**Summary of Notes of BD Forum (2009-2021)**  
**Part I**  
**Building Regulations**

香港建築師學會  
The Hong Kong Institute of Architects

This summary is an extract from the notes of APSEC (Authorised Persons, Registered Structural Engineers and Registered Geotechnical Engineers Committee) Discussion Forum with BD for easy reference by HKIA members. The Forum was held regularly since 2009, and the notes were endorsed by BD for every Forum since 2012. Members may refer to the Forum notes for the full and official version.

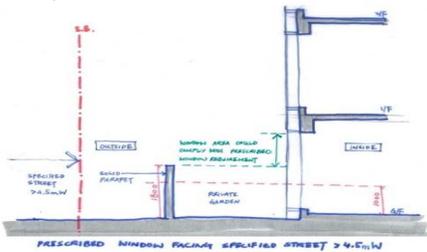
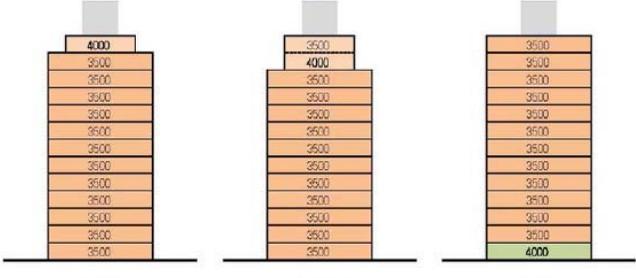
<p><b>(b) Headroom of Bathrooms</b></p> <p>Pursuant to ADF 2/2014, it is suggested to define the minimum floor to ceiling headroom requirement for bathroom to 2.3m to avoid argument on measurement as most bathroom sometimes involve drop slab or flat beam. False ceiling and bulkhead would be disregarded in the measurement of the headroom and prescribed window requirement would not be required for bathroom.</p>	[B(P)R] 24	<p>Item 1 ADF 3/2014 HKIA</p> <p>follow up of Item 3 ADF 2/2014</p> <p>Item 1 ADF 5/2019</p>	To facilitate further discussion, HKIA would prepare justifications for the proposed 2.3m bathroom clear height measured from the floor to the soffit of the sunken slab above.

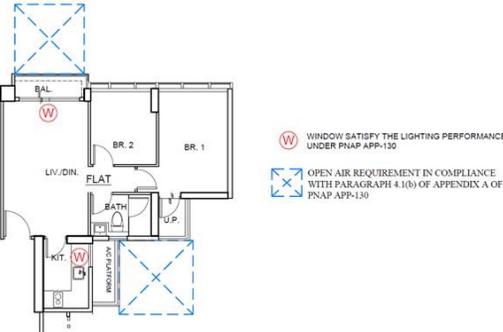
<p><b>Protective Barrier at Window and Openable Area Calculation</b></p> <p>It is our understanding that glass protective barrier in front of openable window can be ignored in the calculation of area required under B(P)R30(2)(a)(ii) as demonstrated in the diagrams below. Would BD confirm .....</p>	<p>B(P)R 30(2)(a)</p>	<p>Item 16 ADF 2/2017 AAP</p>	<p>BD advised that while the glass protective barrier in front of the openable window would be considered as obstructing ventilation, protective barrier in form of well perforated metal grilles would usually be acceptable.</p>
<p><b>Mechanical Ventilation of Room containing Waste Fitment</b></p> <p>ADF 2/2017 ..... where a waste fitment was located right next to the openable window in a large open plan area due to functional reason, would BD consider accepting the application of the same notional area of 1.5 x 1.5m per sink/basin in the calculation of window requirement on a case by case basis.</p>	<p>B(P)R 36</p>	<p>Item 11 ADF 3/2017 HKIA</p> <p>also refer Item 3 ADF 2/2017</p> <p>Item 1 ADF 1/2018</p>	<p>BD advised that they would favourably consider the application of a notional area of 1.5m x 1.5m per sink/basin in the calculation of window requirements for large rooms on a case basis; and submission of Form BA16 with respect to B(P)R 36(2) would not be necessary.</p>

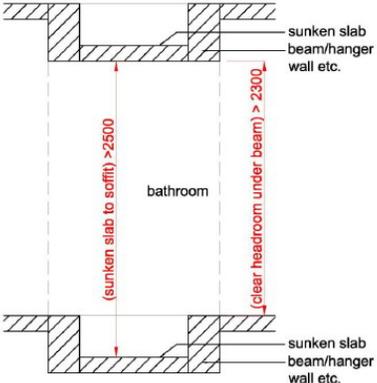
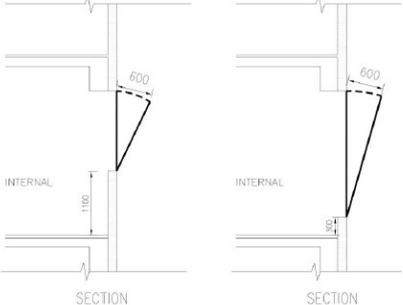
<p><b>Lighting and Ventilation</b>            our understanding ..... where a full height window (such as a french window or sliding door ..... to a balcony) meeting the requirement of B(P)R 31(a) [i.e. it faces into a street which is not less than 4.5m wide], the whole glazing area of such window including that portion below 1m A.F.F.L. can be counted towards the aggregate superficial area of glass in the window as required under B(P)R.... That said, the requirement of just counting that portion of glazing at 1m A.F.F.L. and above for fulfillment of B(P)R 30(2)(a)(i) is applicable only to those prescribed windows adopting Rectangular Horizontal Plane (RHP) as per B(P)R.....</p>	B(P)R 30, 31	Item 2 ADF 5/2017 HKIA  also refer Item 16 ADF 2/2020	<p>BD advised that B(P)R 31(3)(b) regarding sill level of a prescribed window should also be applicable to B(P)R 31(1)(a). In other words, the requirement of just counting the portion of glazing area at 1m A.F.F.L. and above for fulfillment of B(P)R 30(2)(a)(i) was also applicable to prescribed window faced into a street which was not less than 4.5m wide.</p> <p>[Post-meeting notes: The same issue was raised again in BSC/APSEC Meeting held on 8.12.2017. After review, BD considered that the deemed level of sill as stipulated under B(P)R 31(3)(b) is for the purpose of assessing RHP mentioned in B(P)R 31(1)(b).]</p>

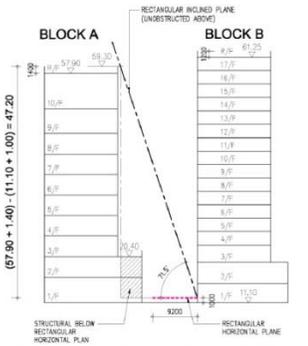
<p><b>Utility/Store Room adjacent to Domestic Kitchen</b>  Some members reported that the maximum dimension of utility/store room of not more than 1.6m was required by BD recently. However, we understand from previous ADF discussions that there is no such requirement on the maximum dimension of utility/store room. We wish to know if BD's practice has been changed.</p>	<p>B(P)R 30,31</p>	<p>Item 9  ADF 1/2018  AAP</p> <p>also refer  Item 12  ADF 5/2014</p> <p>Item 12  ADF 1/2016</p> <p>Item 2  ADF 5/2018</p>	<p>BD advised that there had been no change in the policy towards store /utility room in domestic unit since the discussion vide ADF 5/2014. BD would consider the proposal on case basis as discussed in ADF 5/2014. In general, the size of the utility / store room should commensurate with that of the unit.</p>

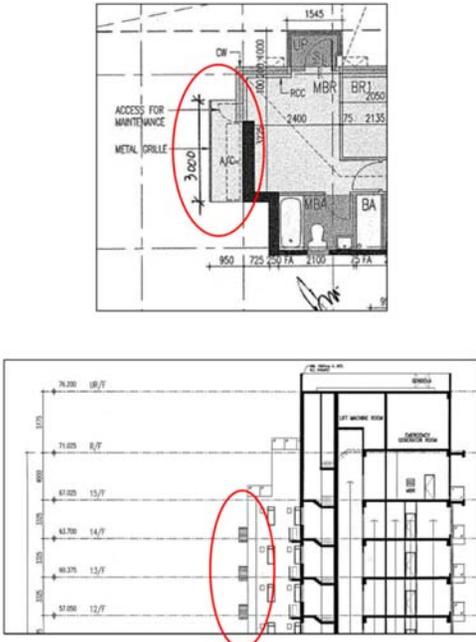
<p><b>Determination of Openable Window Area</b></p> <p>For openable bottom-hung window (Case A and Case B below), if the openable extent is not less than 600mm at the top of sash to window frame, its openable window area is to be calculated based on the elevation area of such window:</p>  <p>Please clarify if, for some other special window like cassette-type window, the openable window area is the summation of all the openable areas (i.e. the gaps) on four sides of such window:</p> 	B(P)R 30,31	<p>Item 23 ADF 5/2019 AAP</p> <p>also refer Item 15 ADF 1/2020</p>	<p>For bottom-hung window, BD confirmed that if the openable extent of the window was not less than 600mm, its openable window area should be calculated based on the elevation area of such window. In any case, regulation 8 of Building (Construction) Regulations should also be compiled with where there was a difference in adjacent levels greater than 600mm.</p> <p>By the same token, for cassette type of window, if there was 600mm or more clearance provided at the gaps, the openable window area could be calculated based on the elevation area of the window.</p>

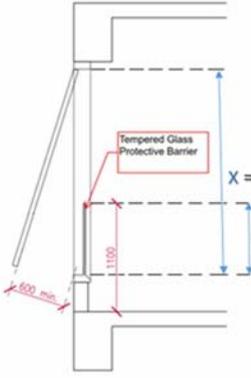
Issue	Reg. / Code Ref.	Date of discussion	BD response
<p><b>Service Lane (cont'd)</b>                      Scenario 2                      When there is no existing service lane and the site is abutting an existing slope, the building on the site is to set back 1.5m from the lot boundary as shown in the diagram.</p>  <p>PLAN OF SET BACK FOR SERVICE LANE OF REDEVELOPMENT (SCENARIO 2)                      (CLASS A SITE)</p>		<p>Item 15                      ADF 4/2020</p>	
<p><b>Inclusion of AC Platform in Roofed-Over Area for the Purpose of Open Space Calculation</b>                      In the past, there is no need to include the area of AC platform in the calculation of roofed-over area but recently it is required to do so. The AC platform is not accessible from the roof (except for maintenance) and there is no accountable GFA &amp; site coverage underneath. So, we would like to clarify whether inclusion of the AC platform area is necessary for calculation of roofed-over area for the purpose of open space calculation as illustrated in the diagrams below.</p> 		<p>Item 9                      ADF 1/2021                      HKIS</p>	<p>BD advised that subject to the compliance with the relevant criteria under paragraph 3 of PNAP APP-19 for exclusion from site coverage and plot ratio calculations, AC platforms could also be not counted for roofed-over area for the purpose of open space calculation.</p>

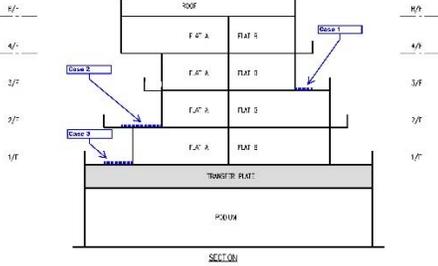
Issue	Reg. / Code Ref.	Date of discussion	BD response
<p><b>Service Lane (Cont'd)</b>            Would BD please clarify if the above is acceptable, providing that a copy of legal instrument (e.g. deed of right of way) can be submitted by the building owner/authorized person to prove that the building owner is expressly granted, by virtue of the instrument, a right of way exercisable at all times over the said private lane.</p>  <p>OPPOSITE ADJOINING BUILDING BOUNDARY LINE            EXISTING SERVICE LANE (1.8M WIDTH)            CENTRE LINE OF SERVICE LANE            SET BACK (RHP) FROM BOUNDARY LINE            BOUNDARY LINE</p> <p><b>PLAN OF EXISTING SERVICE LANE (SCENARIO 1)</b>            (CLASS A SITE)</p>			
<p><b>Height of Balustrade for Balcony &amp; Utility Platform (UP)</b>            Referring to item 16 of ADF 2/2020 held on 29 May 2020, please confirm if the following understanding is correct:</p> <ol style="list-style-type: none"> <li>(1) The rectangular horizontal plane (RHP) does not apply to a prescribed window facing a specified street.</li> <li>(2) Hence, the deemed-to-be level of window sill of the prescribed window opening onto a balcony facing a specified street will not be blocked by balcony, UP, AC platform and the like.</li> <li>(3) Prescribed window area for inclusion into natural lighting and ventilation calculation can carry down to floor level irrespective to the deemed-to-be level of window sill height.</li> </ol>  <p>UNIT BALCONY STREET            1250</p>	<p>B(P)R 31</p>	<p>Item 18            ADF 2/2021            AAP</p> <p>Also refer            Item 2            ADF 5/2017</p> <p>&amp;</p> <p>Item 16            ADF 2/2020</p> <p>&amp;</p> <p>Item 20            ADF 2/2021</p> <p>&amp;</p> <p>Item 3            ADF 3/2021</p>	<p>For (1), BD advised that AAP's understanding was correct. B(P)R 31(1)(a) referred.</p> <p>For (2) and (3), BD advised that AAP's understanding was correct. The deemed level of sill as stipulated under B(P)R 31(3)(b) was for the purpose of assessing RHP mentioned in B(P)R 31(1)(b). For windows, no matter facing street which was not less than 4.5m wide or facing an RHP, the superficial area of that portion of the glazing and window opening at level below 1m A.F.F.L. might also be counted towards the aggregate glazing area and aggregate openable window area as required under B(P)R 30(2)(a)(i) and (ii) respectively. Item 2 of ADF 5/2017 held on 17 November 2017 and item 16 of ADF 2/2020 held on 29 May 2020 were also relevant.</p>
